RE: City of Balltown VARIANCE REQUEST
Dubuque County Iowa Department of Natural Resources

Re: Balltown Waste Water Treatment Works
Variance Request for Balltown Church Well
IIW Project No. 98189-02

IIW ENGINEERS & SURVEYORS, P.C. <small>INDIANAPOLIS, IN 46102-0000 4155 PENNSYLVANIA AVE. DUBUQUE, IA 52002 (319) 556-2464</small>	Project Description	FIELD BOOK: 000	Issued For:	Drawn By:
	1000' TREATMENT SITE OFFSETS			JEM
	WASTEWATER COLLECTION AND TREATMENT FACILITY			Checked By:
	BALLTOWN, IOWA			JEM
Project Number: 88109-02			Item: _____ Date: _____

SUBJECT: City of Balltown site survey

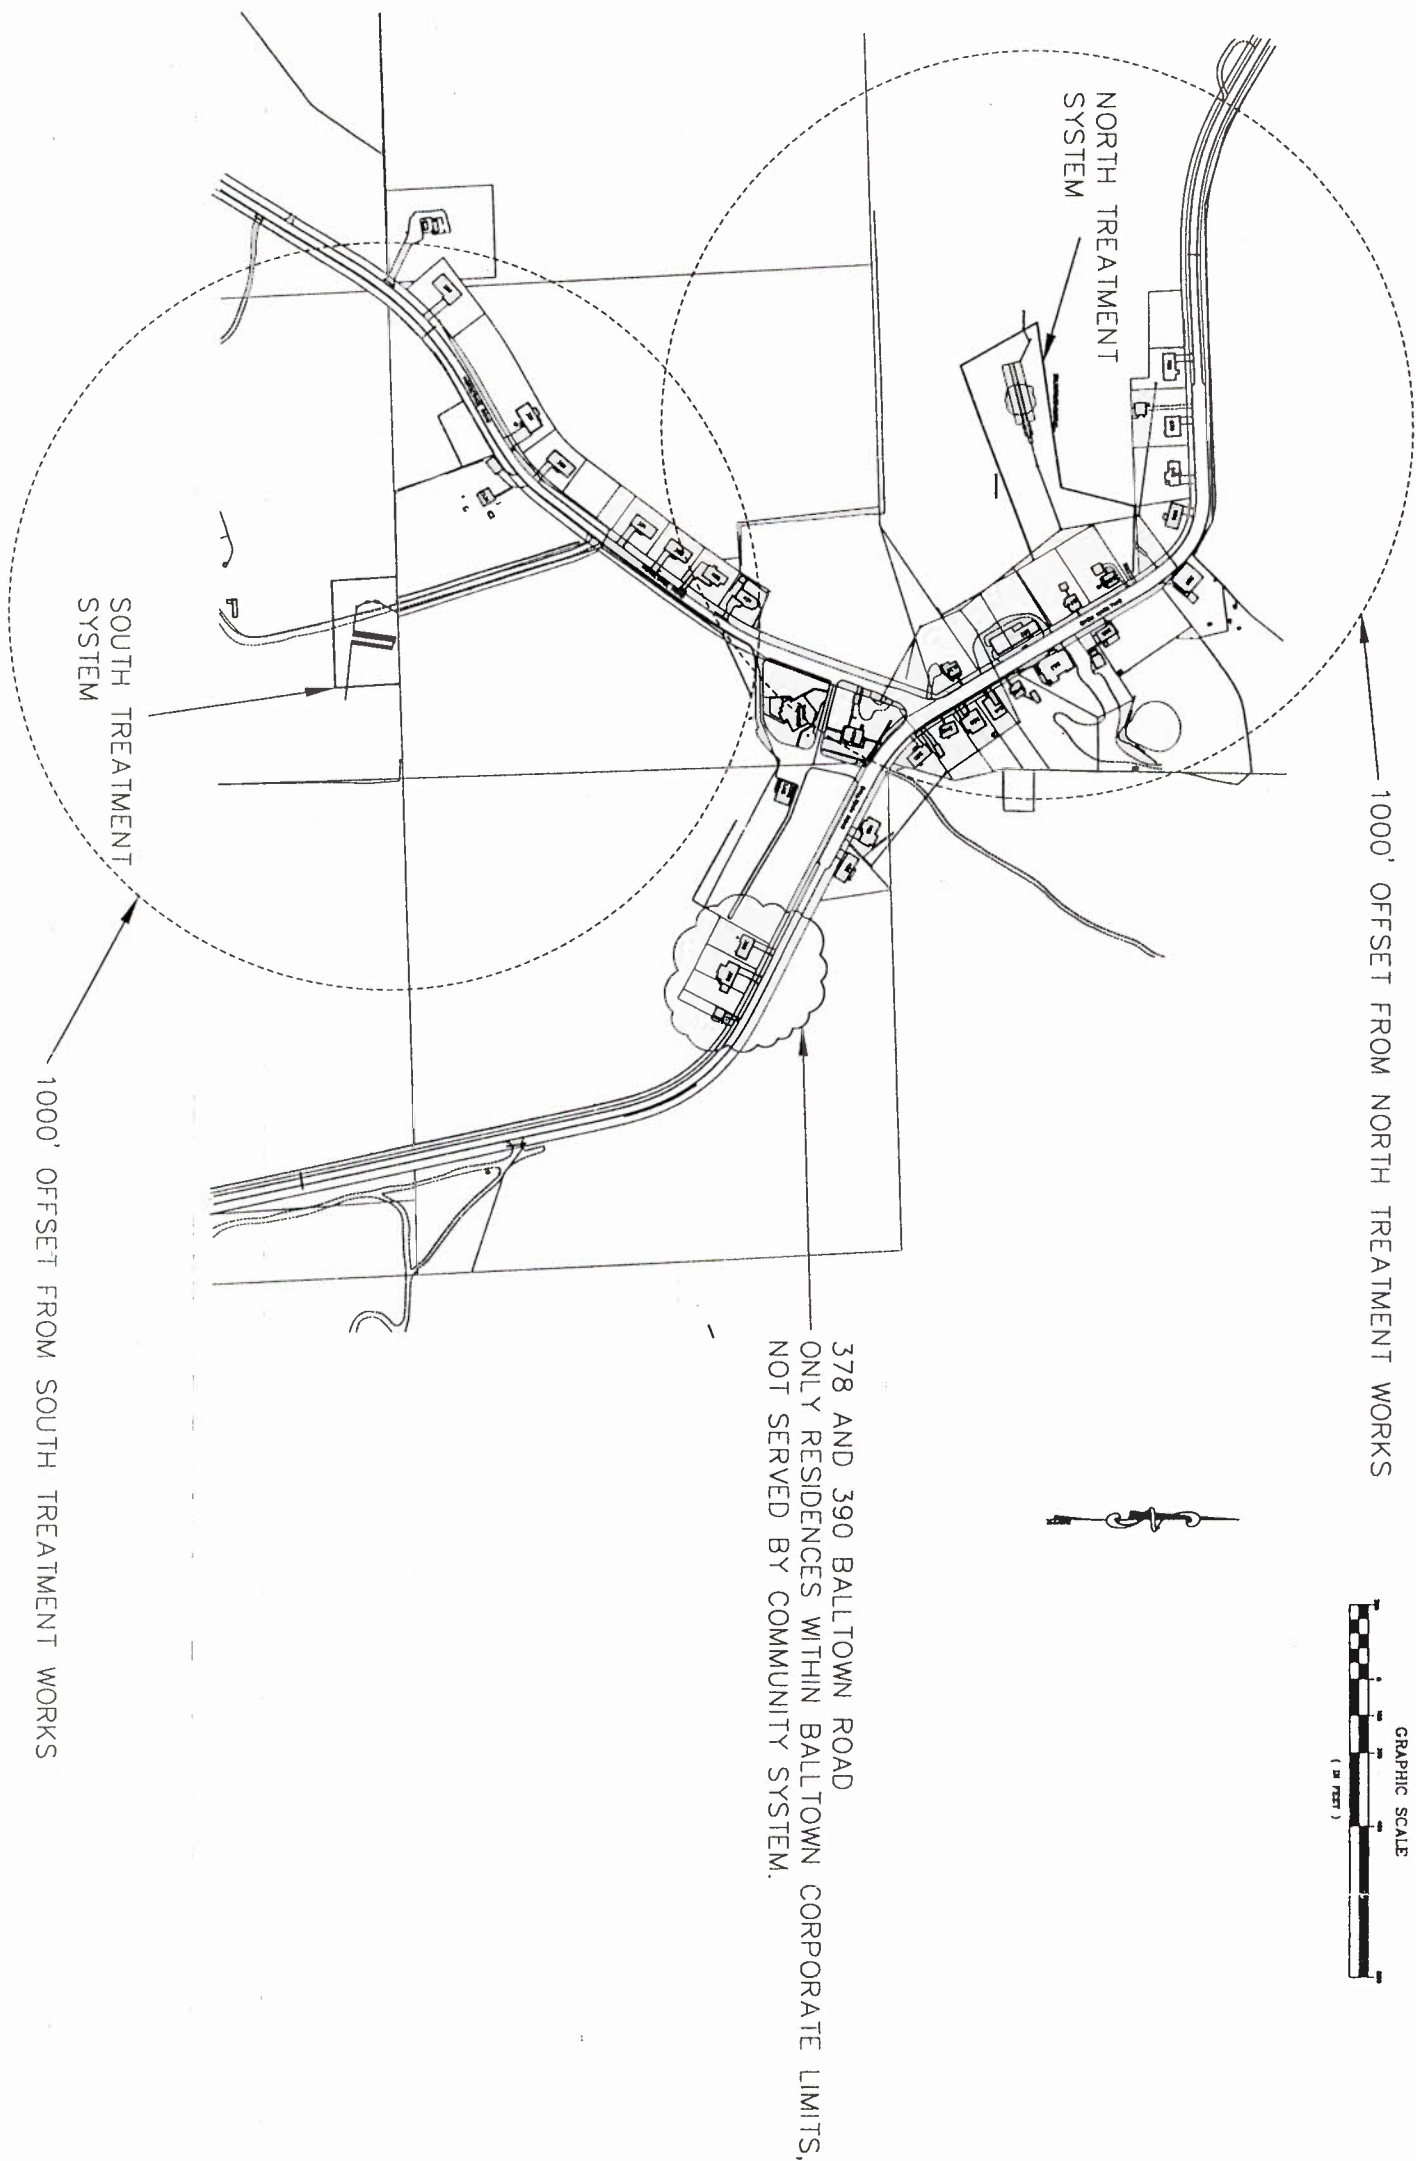
Chapter 64.2(3)b of the Environmental Protection Commission (Section 567) of the Iowa Administrative Code states that the minimum separation distance from a public shallow well is 1,000 feet. The actual distance from Well #12516 to the South Treatment site is 1,102 feet and to the North Treatment Site is 904 feet. Which means that the North Treatment Site does not comply with a strict interpretation of this regulation.

The public well that serves the church and school is a shallow well. This proposed site is 904 ft. from this well. This is just short of the 1,000 ft. separation required from public shallow wells. I believe we should wave this 1,000 ft. separation for 2 reasons:

1. They are continuously chlorinating this water supply.
2. There are presently several existing septic tanks that are within 100 ft. of this well that will be removed when a city system becomes available.

Inasmuch as the separation distance between the North treatment site and the Balltown Church well is 904 feet and several individual on-site wastewater treatment facilities in close proximity to the well will be abandoned and removed, improved effectiveness against possible contamination of the well will be provided.

Due to these facts, we would like to formally request a variance from the separation criteria identified in Chapter 64.2(3)b for the north treatment facility from the Balltown Church Well (Well #12516).

The proposed site for the north treatment facility meets the separation distances listed in IAC 567—64.2(3), except for separation distances from inhabitable residences and from a shallow public well. Written agreements from the owners of the residences will need to be obtained. I recommend we wave the separation distance from the shallow public well for the reasons listed above.
